NEW FIRE STATION: ENGINE CO. 268 / LADDER CO. 137

1 - MECHANICAL SCREEN DIAGRAM

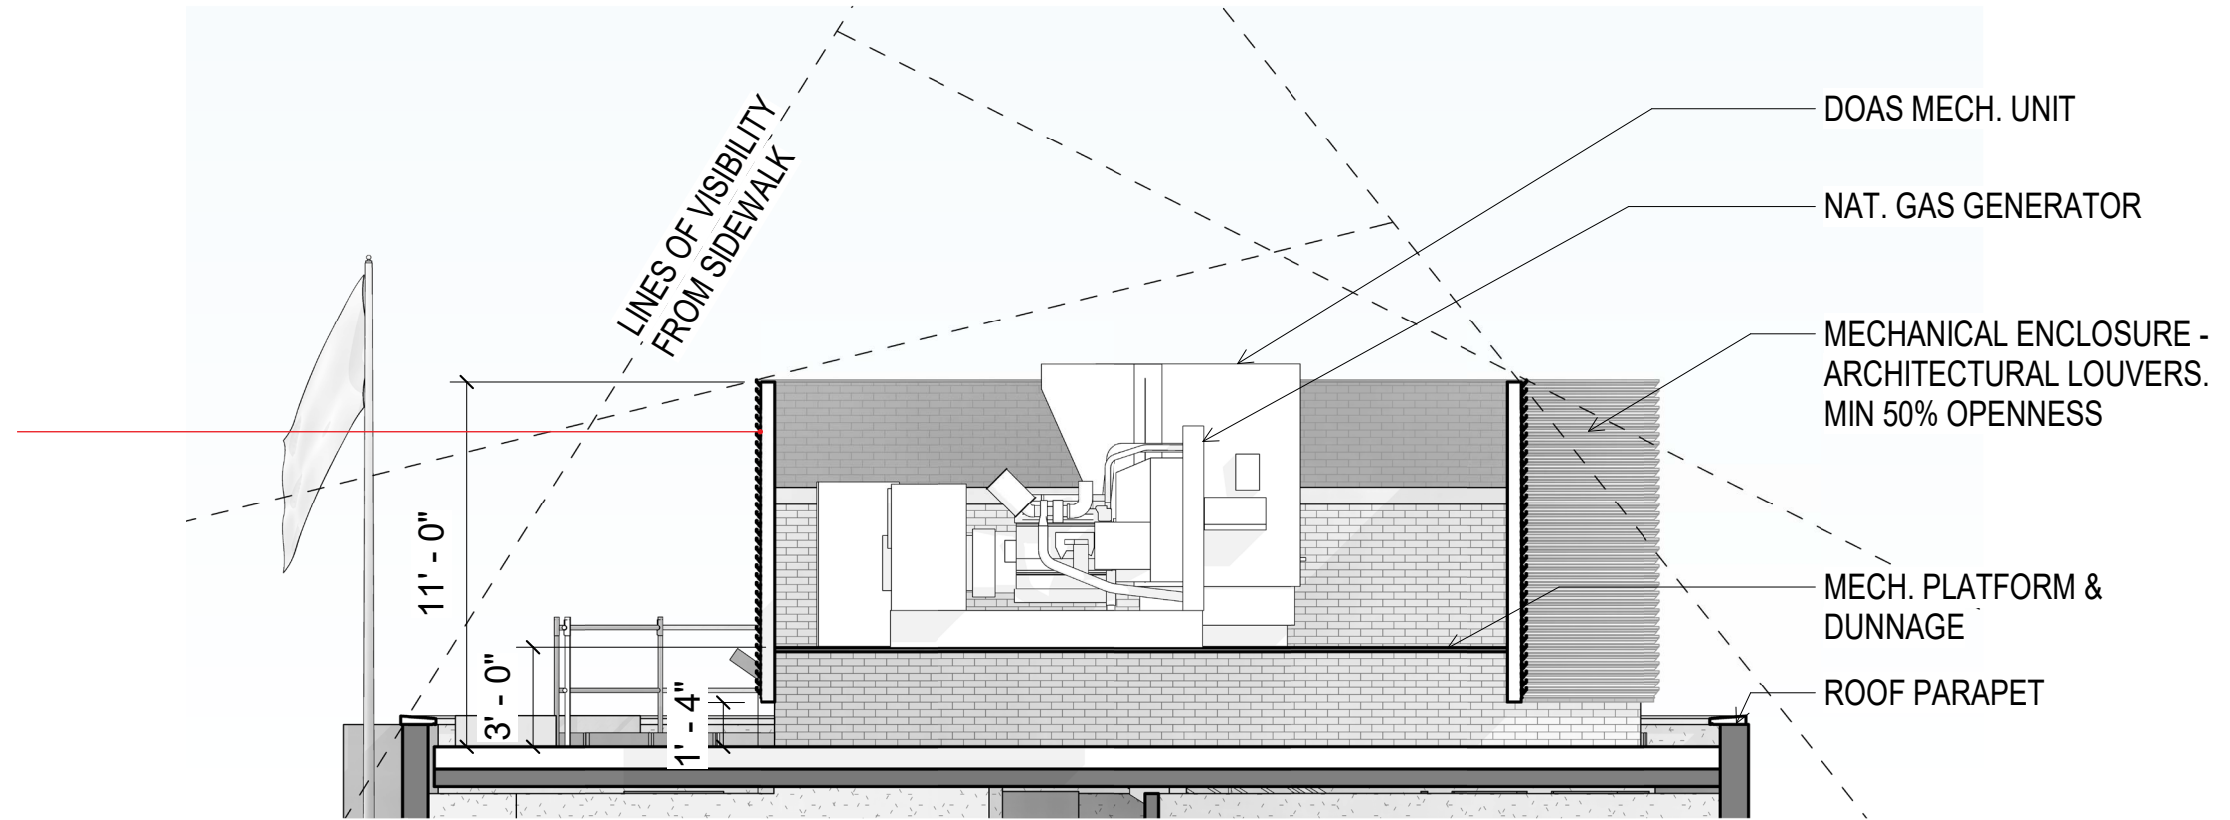
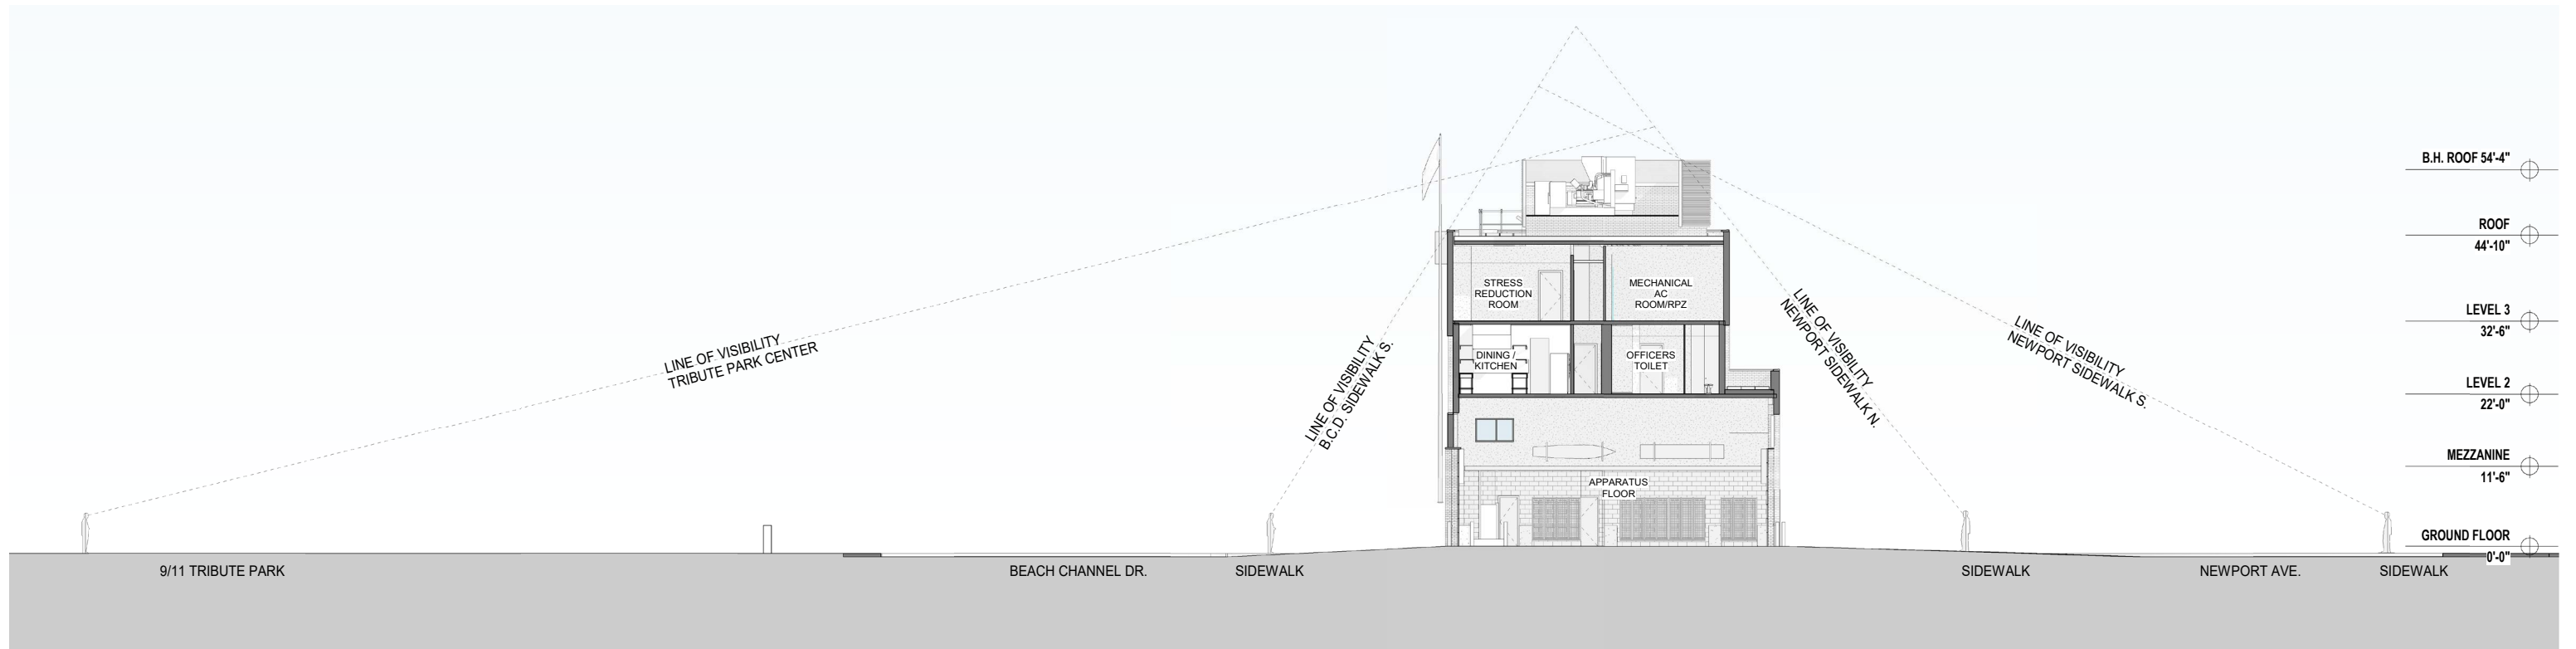
R27A - REVISED MECHANICAL SCREEN ENCLOSURE. SEE REVISIONS LIST FOR A MORE THOROUGH DESCRIPTION OF DESIGN.

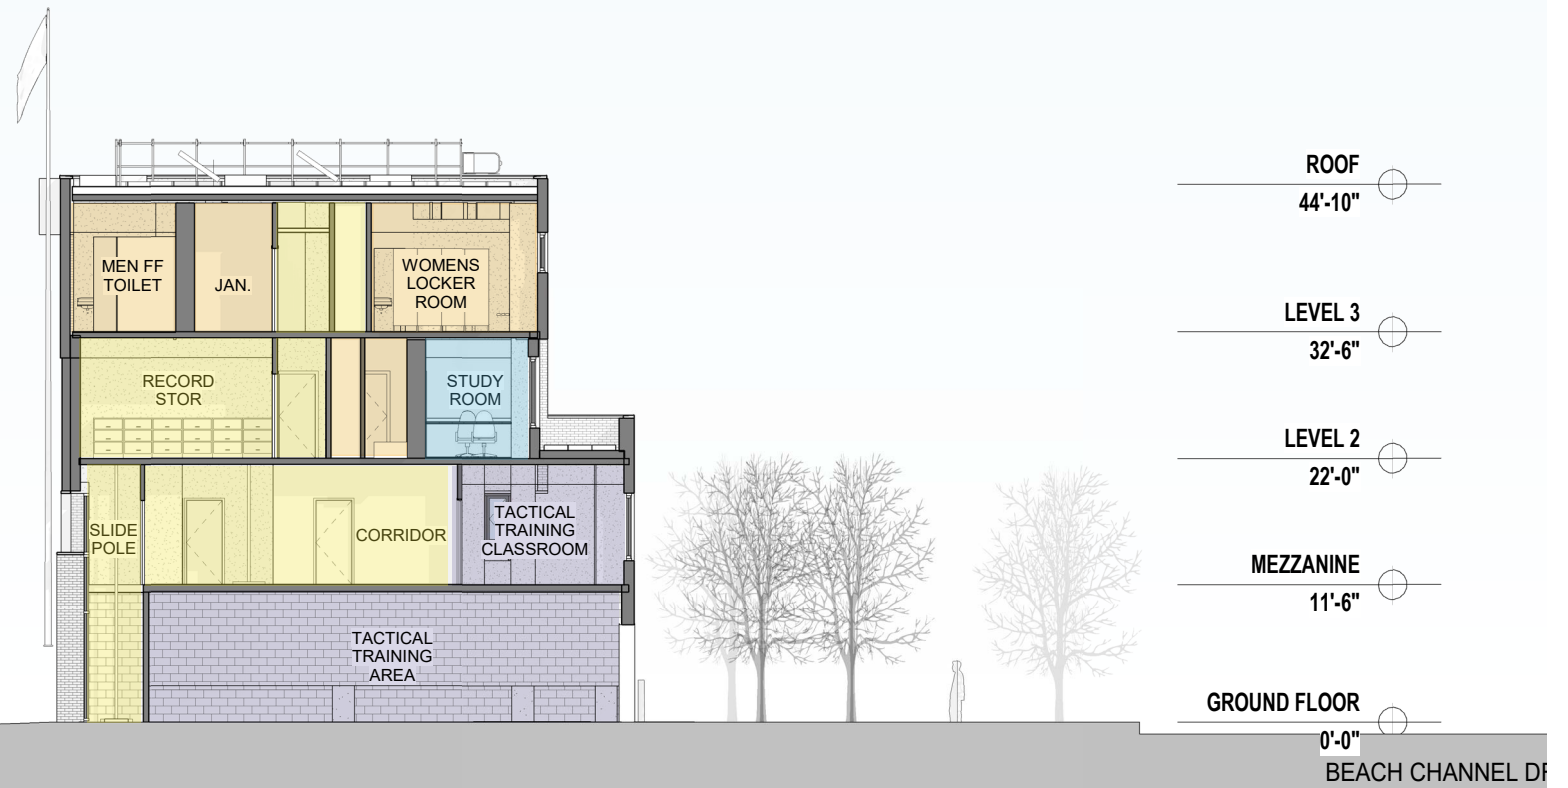
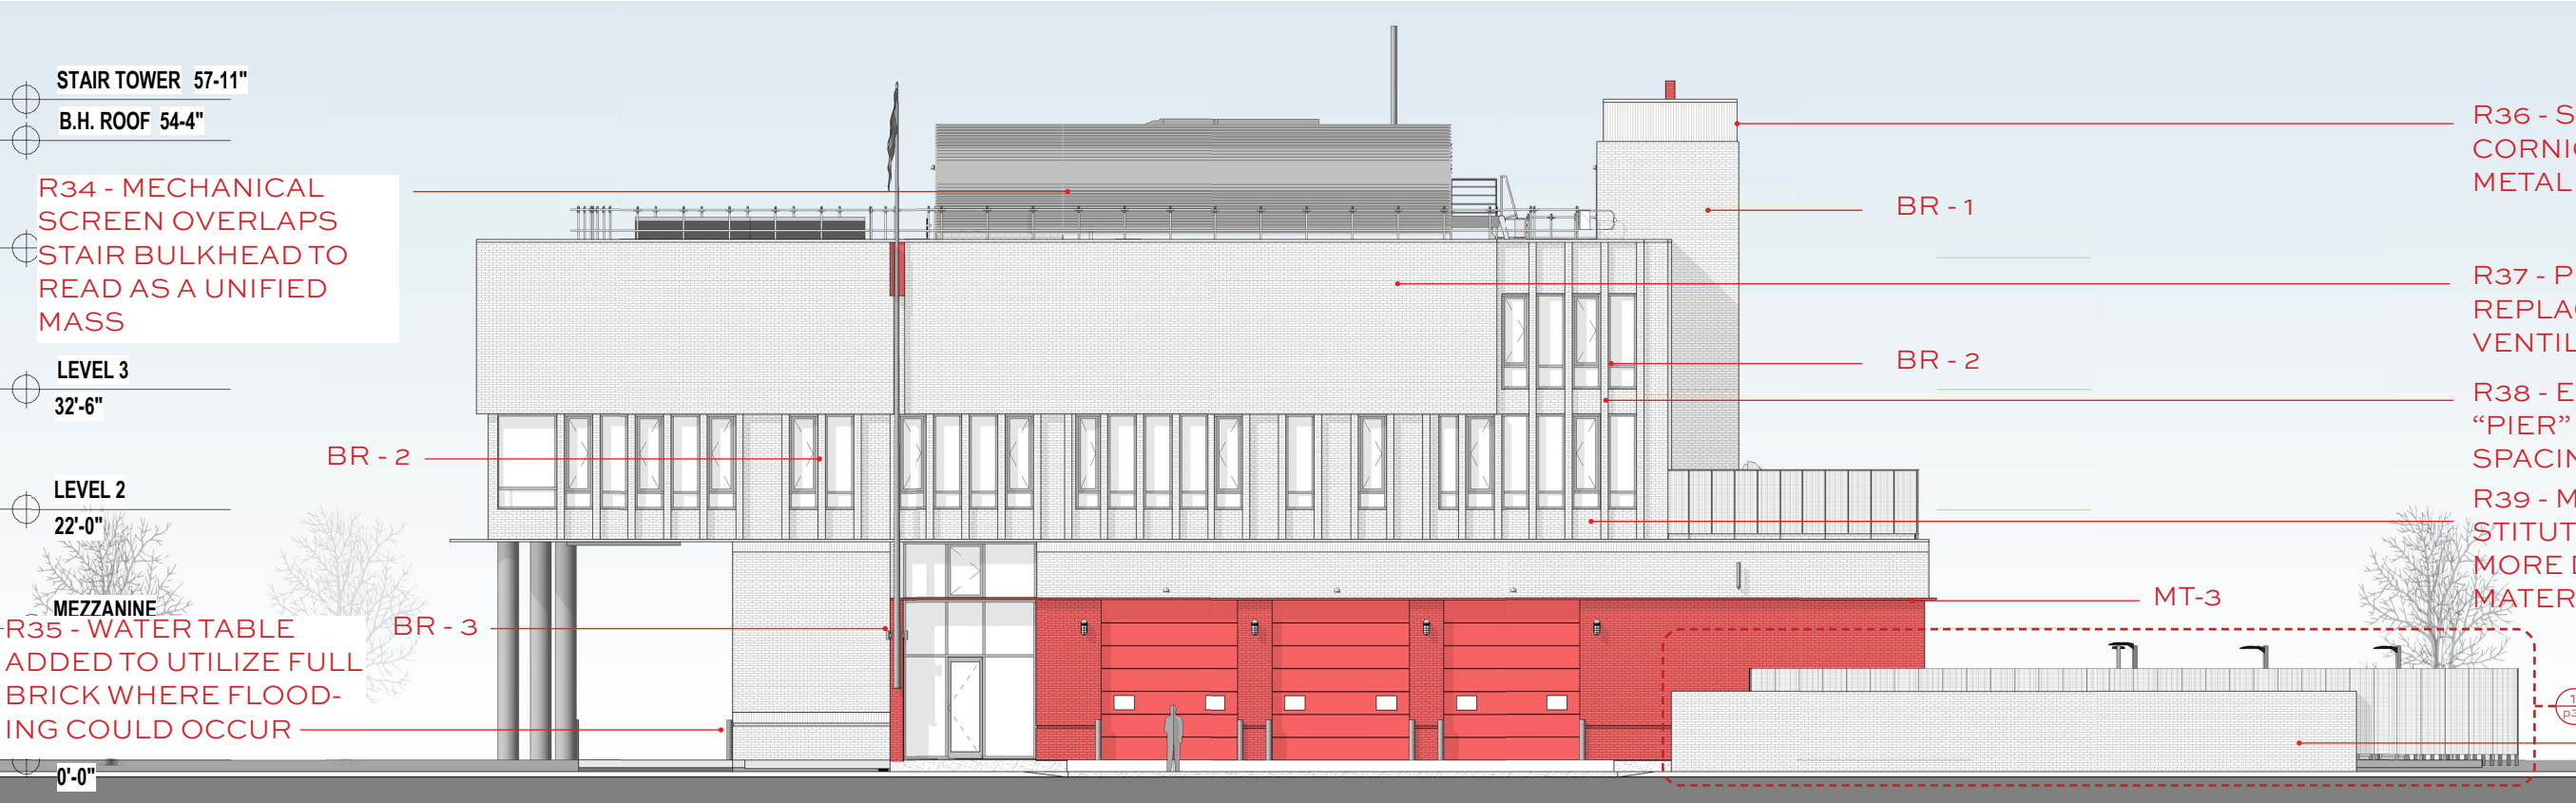
R29 - ROOF DECK AREA
ADDED TO STRESS
REDUCTION ROOM.
WINDOWS AND BRICK
PIER READING
EXTENDED

R-30 - MECH. LOUVERS
REMOVED FROM WEST
FACADE WHERE
GENERATOR WAS
PREVIOUSLY LOCATED

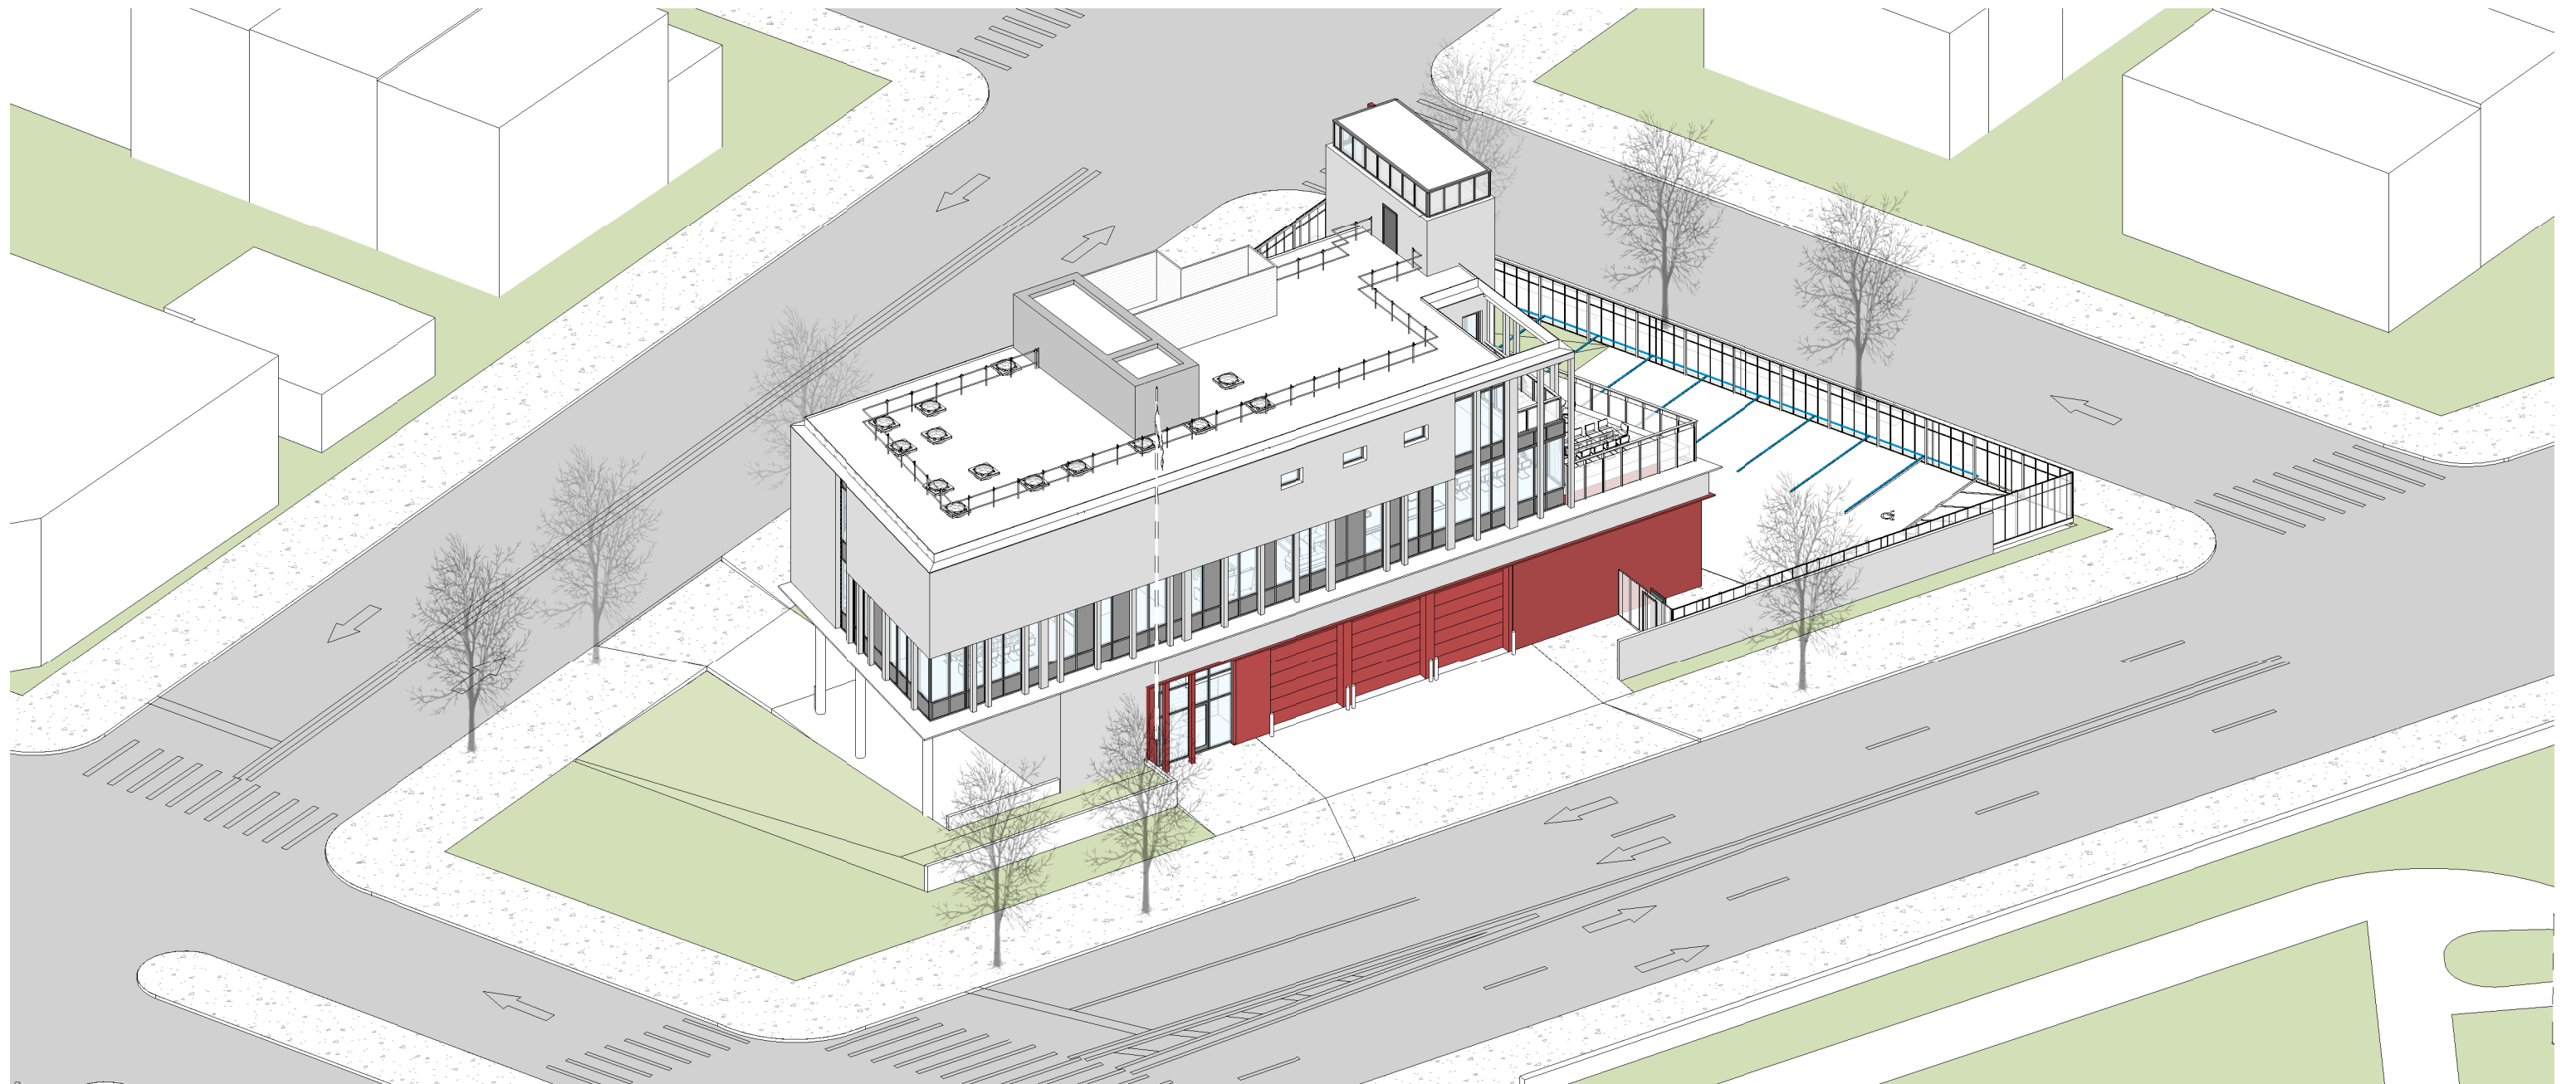
R40 - LARGE WINDOW "SLOT" REMOVED IN LIEU OF VERTICAL WINDOWS AT MEZZ.
